Planning Assessment Officer Report

PA2604262 –10-16A Alverna
Grove and 85-93 Wilson
Avenue, Brighton

Key Information	Details									
Application No:	PA2604262									
Received:	5 March 2026									
Applicant:	Arcare Pty Ltd									
Planning Scheme:	Bayside									
Land Address:	10-16A Alverna Grove and 85-93 Wilson Avenue, Brighton									
Proposal:	Development of the land for a residential aged care facility and the associated display of signage (including illuminated signage) submitted via Clause 53.23 (Significant Residential Development with Affordable Housing).									
Development Value:	\$96,572,000.00 m									
Why is the Minister responsible?	In accordance with the schedule to Clause 72.01 of the Planning Scheme, the Minister for Planning is the responsible authority for matters under Divisions 1, 1A, 2 and 3 of Part of the Act where Clause 53.23 (Significant Residential Development with Affordable Housing) applies.									
Why is a permit required?

Above: Street/front elevation of the proposed building.

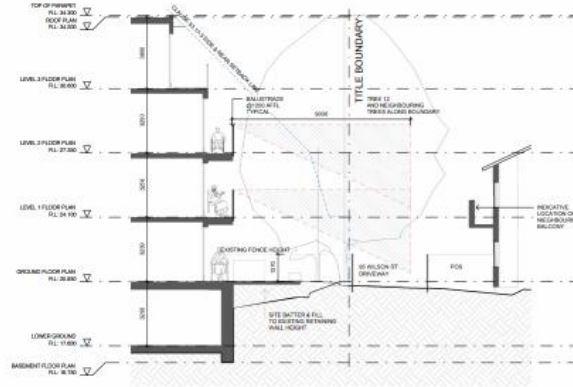
52. Clause 53.17 (Residential Aged Care Facility) prescribes a maximum height of 16 metres for a RAC building in the Neighbourhood Residential Zone, which prevails over any other otherwise applicable building height requirement in the planning scheme. The building is proposed to be constructed to a maximum height of 14.92m (to the top of roof parapet) and is therefore compliant with the height requirement of Clause 53.17.

53. It is noted the maximum building height excludes roof top services, which in some areas are proposed to exceed 16m above the natural ground level. Some of the building services, including a stairwell, will exceed the building height requirement by up to approximately 0.5m. Their position within the built form is well setback from the building edges and is unlikely to be visually discernible from the public realm and adjoining properties. Notwithstanding this, some further detail is recommended to be secured by condition, to confirm the height of the 3rd level roof canopy above NGL. The purpose of this condition is to ensure structures other than services, do not exceed the building height requirement of Clause 53.17.

54. The proposed building height is to vary across the site and will present as a three-storey form with a recessed fourth storey to Alverna Grove and to each adjoining property. The variation in height and recession of upper levels will assist in ensuring the building mass is not unreasonably dominant, particularly in the streetscape context. A streetscape render demonstrating the recession of the 4th floor level is shown below to demonstrate:

Above: Sections with the Clause 53.17 setback line shown in blue.

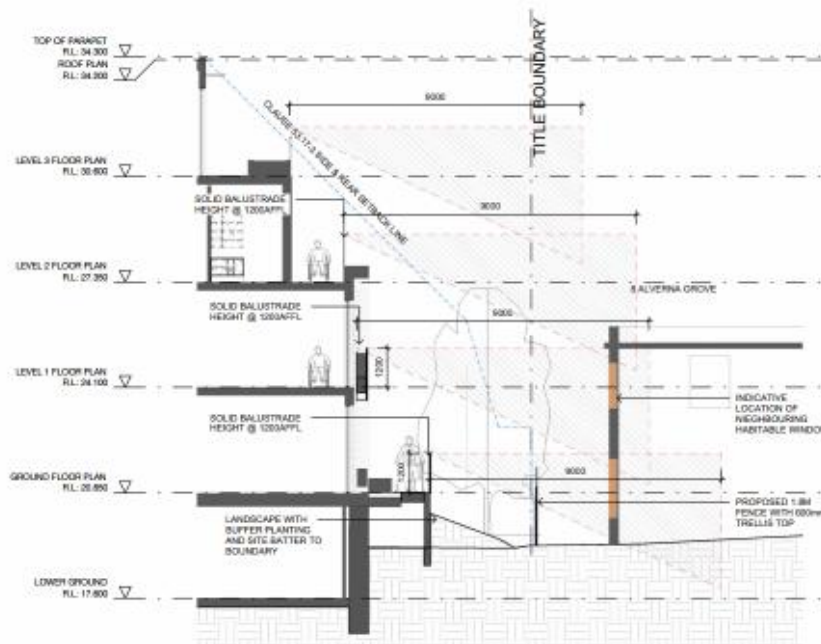
58. It is noted that the submitted planning report states that the proposal sits within the required setbacks of Clause 53.17, as demonstrated by the submitted section drawings. While the section drawings do indicate compliance, the maximum wall heights are not confirmed on some of the sections and there is potential for un-identified variations to the 53.17 setback requirements, at roof parapet level. To address this, a condition is recommended to be included on the planning permit requiring the following:

- The section drawings updated to show maximum proposed wall heights to Level 3/roof level with any necessary alterations to demonstrate Level 3 complies with the side and rear setback development requirement of Clause 53.17.

59. It is noted that there are several instances where the terrace screens/balustrades encroach into the setback line on level 2. This is an allowable encroachment pursuant to Clause 53.17. The below sections assist in demonstrating how the proposed building sits within the setback line requirement:

Above: 2pm Shadow diagrams (blue is existing and pink is proposed).

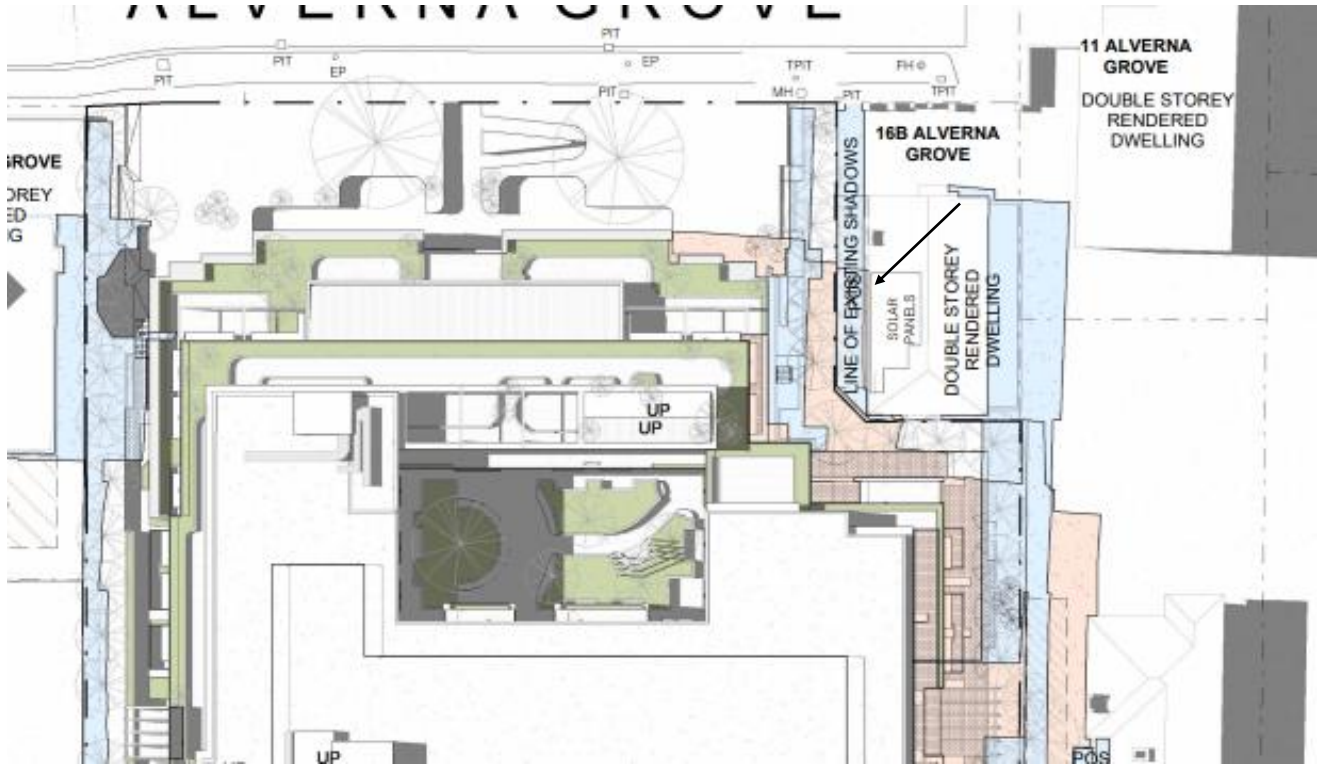
73. However, the shadow diagrams demonstrate that at 2pm on the September Equinox, the development will cause some new overshadowing over the SPOS area of 16B Alverna Grove, shown below. At all other times, overshadowing from the development generally falls within the shadow lines of existing structures.

74. The extent of overshadowing at 2pm equate to approximately 8.225sqm. While the area of SPOS is not the adjoining dwelling's only area of open space, it is noted this would likely be used most frequently due its position adjoining the open living, kitchen dining room. The overshadowing is a variation to Clause 53.17, because this SPOS area does not currently receive sunlight in accordance with the requirements. Given the size of the development site, it is considered there are no constraints that would warrant the need to impact the decking area of the adjoining property, and the issue can be fixed without unreasonable alterations to the floor layouts. Accordingly, this matter is recommended to be addressed by a condition which requires built form alterations as necessary to eliminate new overshadowing over the side deck of 16B Alverna Grove. This has been agreed with the permit applicant.
